**Erie County Sewer District No. 8
Geneva Road Pumping Station and
Sanitary Sewer Extension Project
Contracts 11A and 11D
ADDENDUM No. 2**

**ADDENDUM NO. 2
COUNTY OF ERIE
DEPARTMENT OF ENVIRONMENT AND PLANNING
ERIE COUNTY SEWER DISTRICT NO. 8
GENEVA ROAD PUMPING STATION AND
SANITARY SEWER EXTENSION PROJECT
CONTRACTS 11A AND 11D**

- **DELETE/ADD** - Delete pages: P-7A-3 and P-7A-4 and P-7A-7 in their entirety from the Proposal section of the Contract Specifications and from the separately bound Proposal booklet, and insert pages P-7A-3R, P-7A-4R, and P-7A-7R in their place in the proposal section of the Contract Specifications and the separately bound Proposal booklet. (Attachment VI) General contractor to include cost for revised Proposal pages into Bid.

STILLING WELL INSTALLATION DETAIL

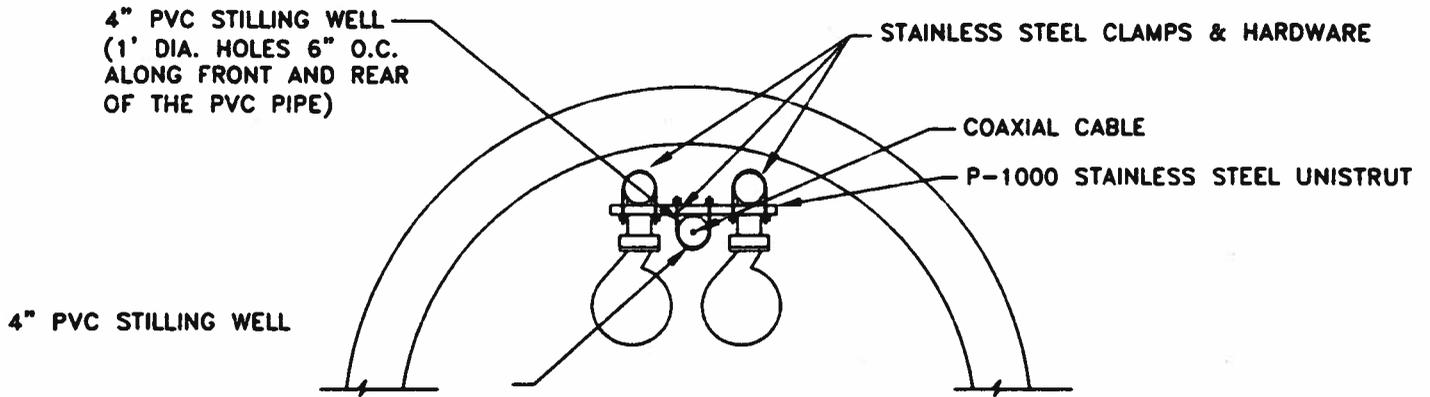
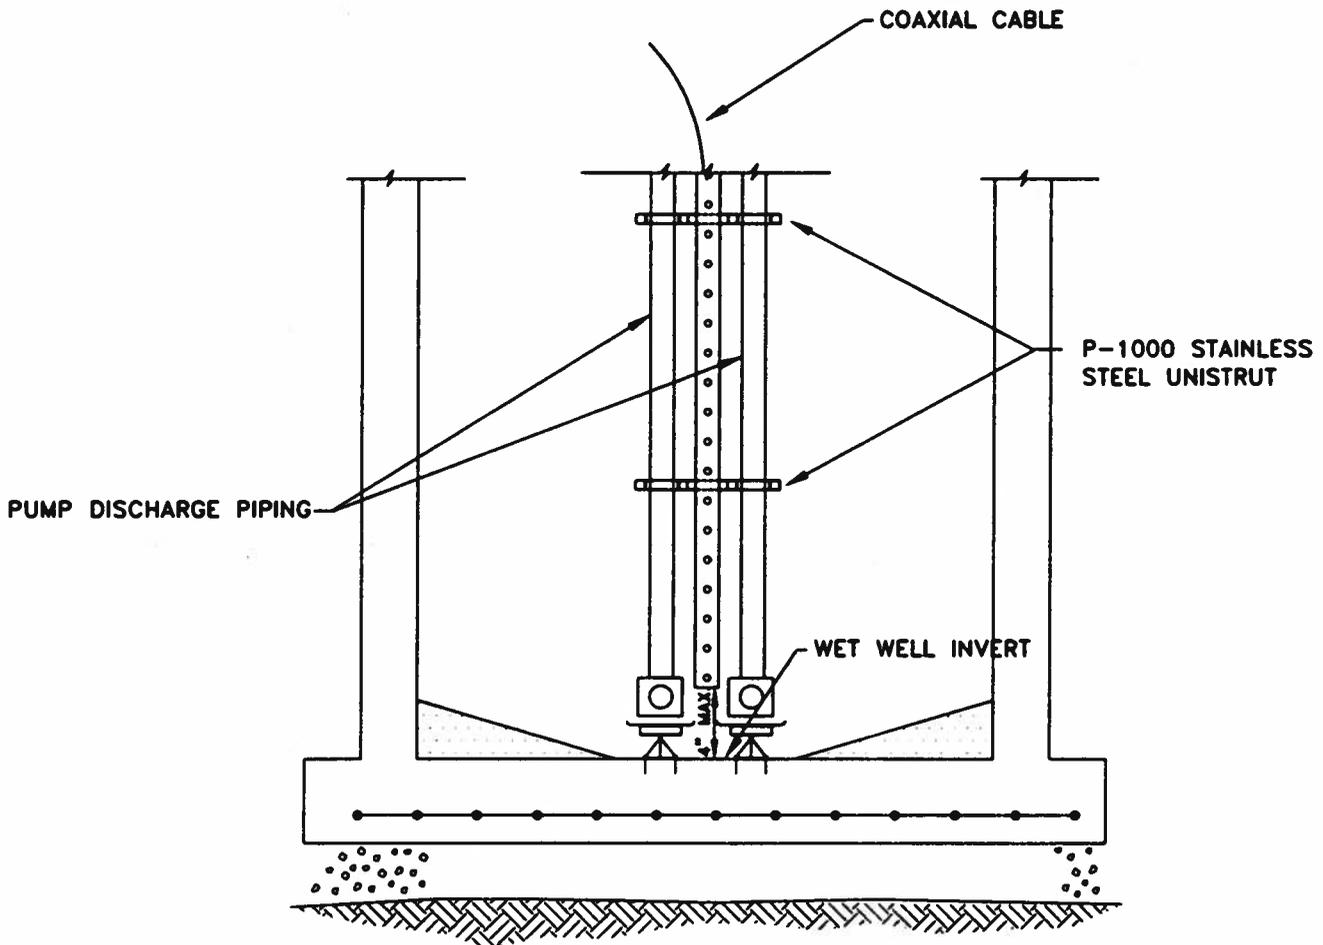
- **ADD** - Stilling Well Installation Detail to contract documents. General contractor to provide stilling well for pumping station as part of Contract Requirements, and include cost in Bid Item No. 29. (Attachment III)

POWER POLE DETAIL

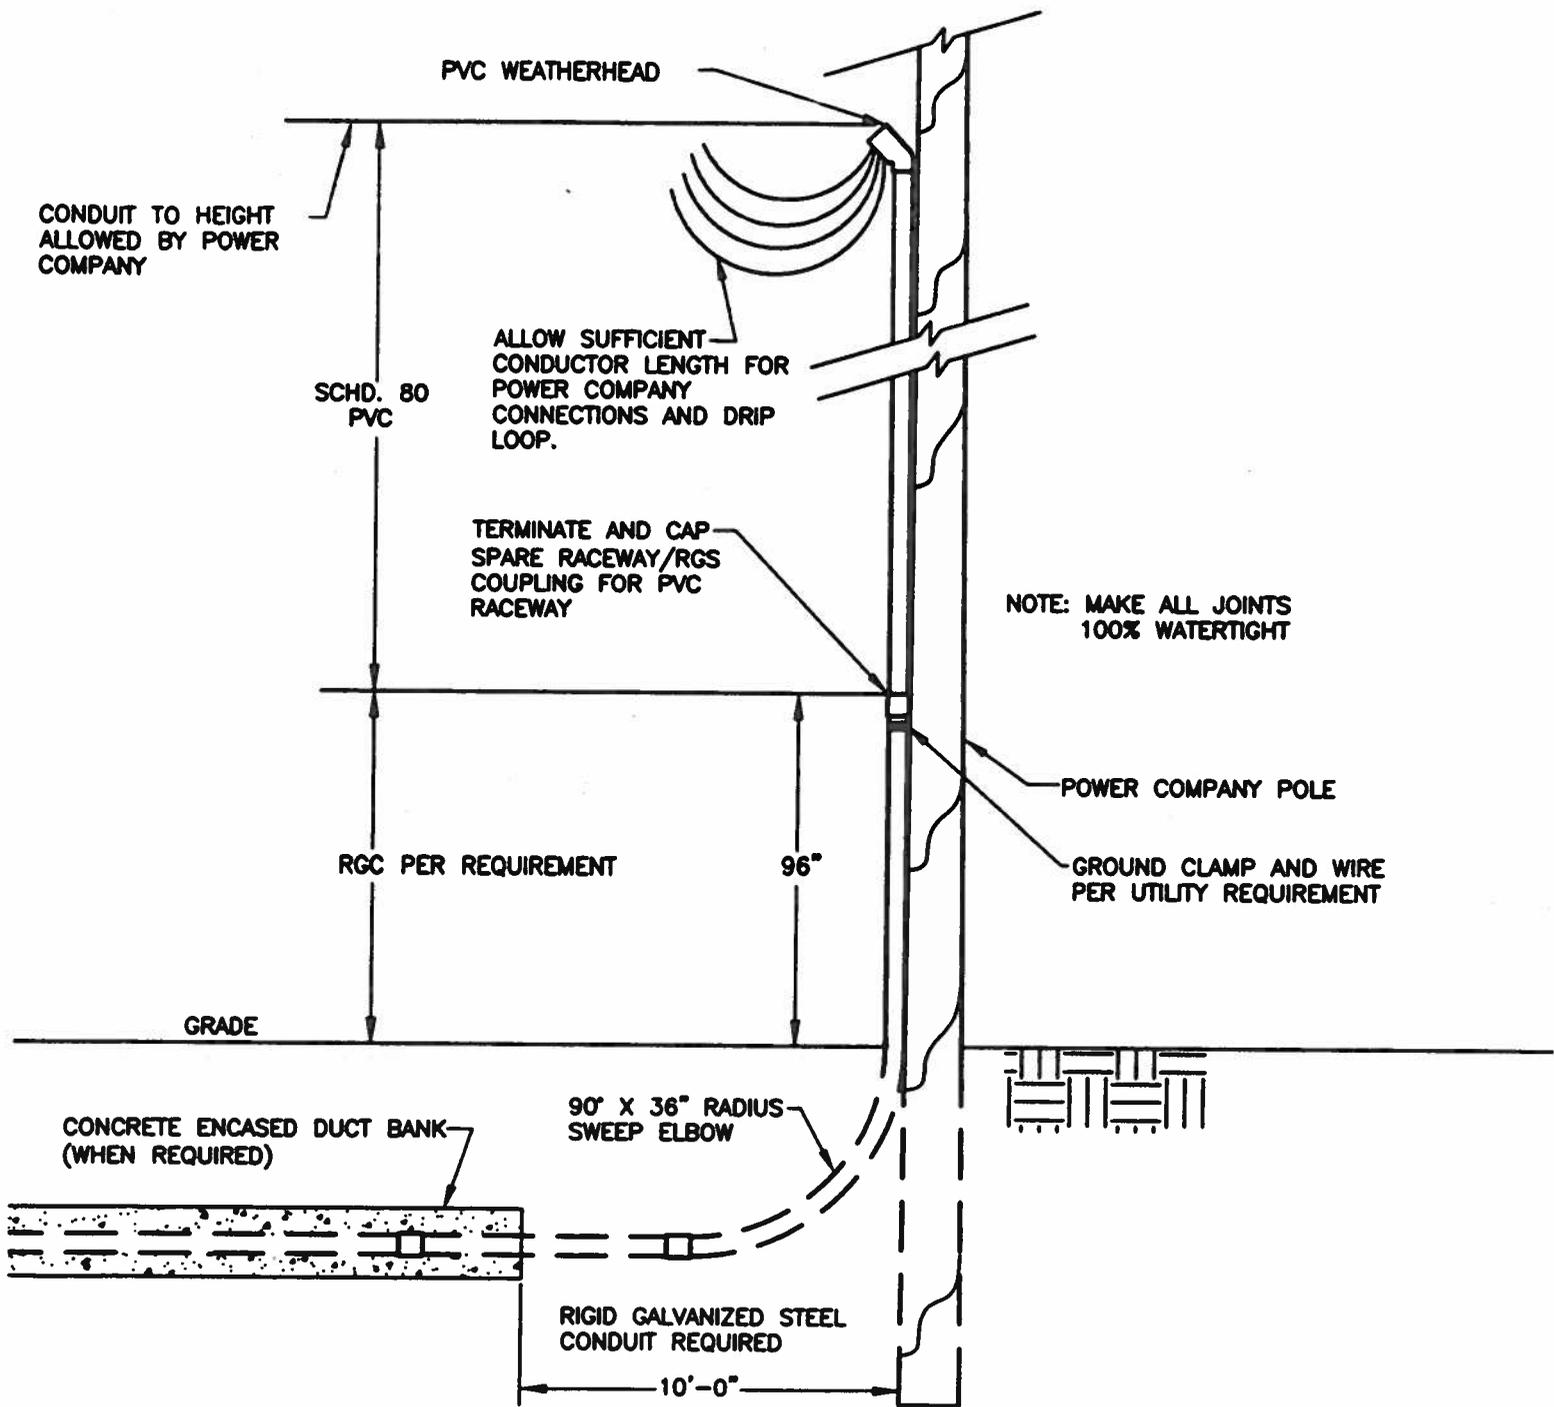
- **ADD** - Electrical Service Drop Detail to contract documents. Electrical contractor to install service drop per detail as part of contract requirements, and include cost in Bid Item No. D-1. (Attachment IV)
